REFERENCE: University of Massachusetts-Lowell Research Reactor
Docket No. 50-223; License No. R-125

SUBJECT: Response to NRC letter dated July 19, 2019 – Request for Additional Information Regarding the Renewal of Facility Operating License No. R-125 for the University of Massachusetts-Lowell Research Reactor and Primarily Related to Instrumentation and Controls (EPID No. L-2015-RNW-0001) and Request for 60 day extension to respond to specified RAI related to same.

Enclosure:
Response to NRC RAI letter dated 07/19/19

Fig.1 – Reactor Power Channels

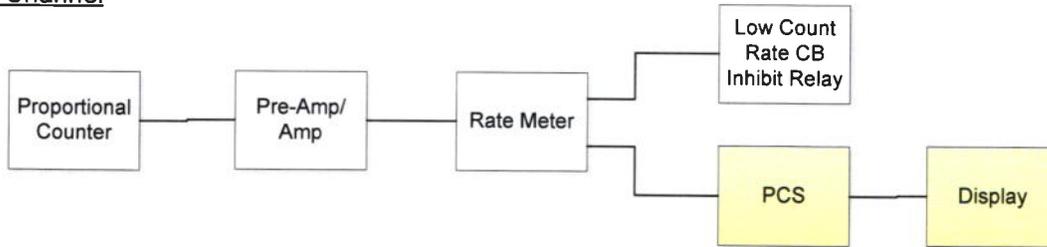
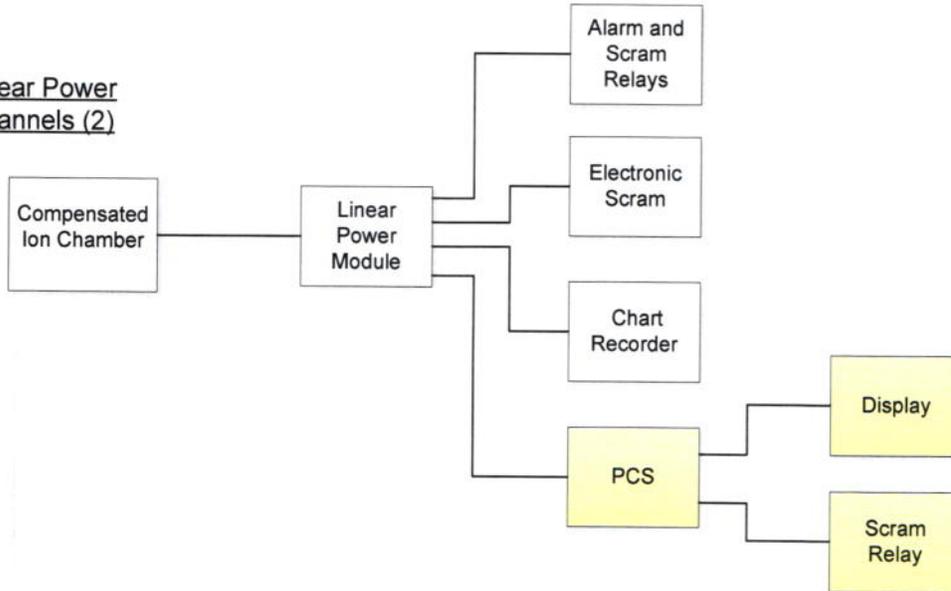
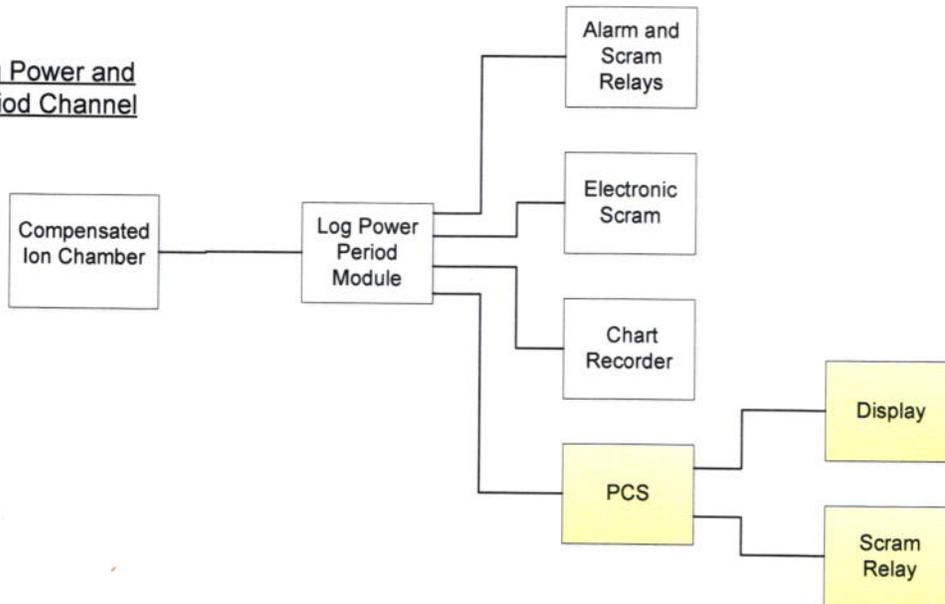
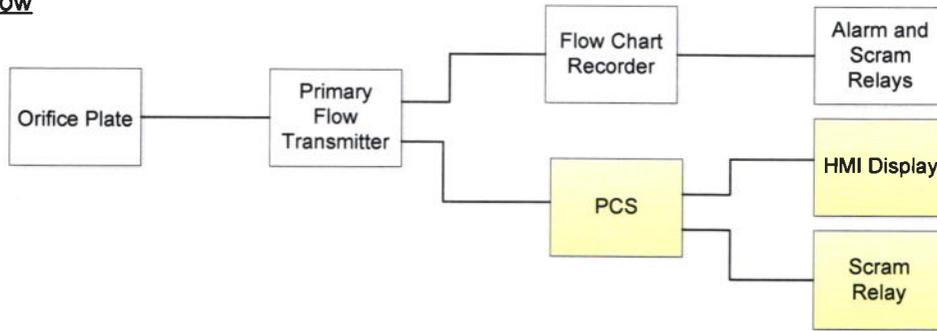
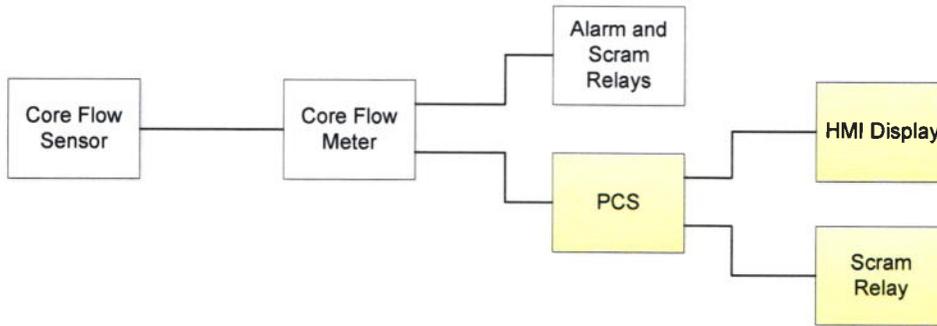
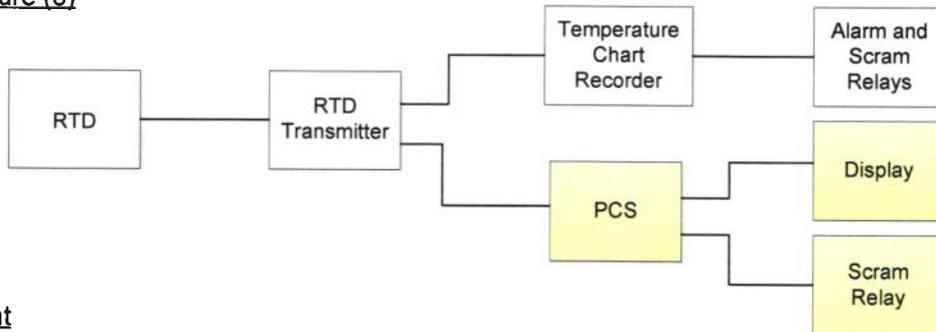
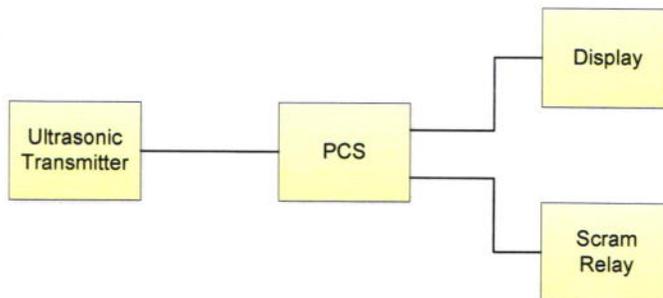
- b. Provide copies of the 10 CFR 50.59 reviews (or screens) listed in RAI Table 7-1 below, to allow the NRC staff to effectively evaluate the current I&C system for license renewal. Additionally, provide copies of the 10 CFR 50.59 reviews (or screens) for any other modifications to the facility since the last license renewal that UML determines could impact the current (or proposed) UMLRR I&C systems, if any. Alternatively, provide a detailed evaluation and discussion of the changes listed below (and any other relevant changes), including descriptions of any modification or addition to, or removal from, the facility or procedures that affects the I&C system design function, or method of performing or controlling the function; and, their impact on UMLRR operations.

Figures 1 and 2 attached provide block diagrams showing the devices associated with reactor safety system (RSS) process variables (reactor power, coolant flow, coolant temperature, and pool height) attached to the PCS. The analog inputs to the PCS are attached to auxiliary analog output points from the devices and are optically isolated. For pool height, in addition to the existing float switch, a new ultrasonic sensor has been added to provide a reading of the actual pool height. As shown in the block diagrams, the PCS does not replace any functionality, but it does provide additional diversity and redundancy to the RSS. The PCS also includes a dry contact relay connected to the scram chain. If communication between the boards, controller, or displays is lost, the relay will open and scram the reactor.
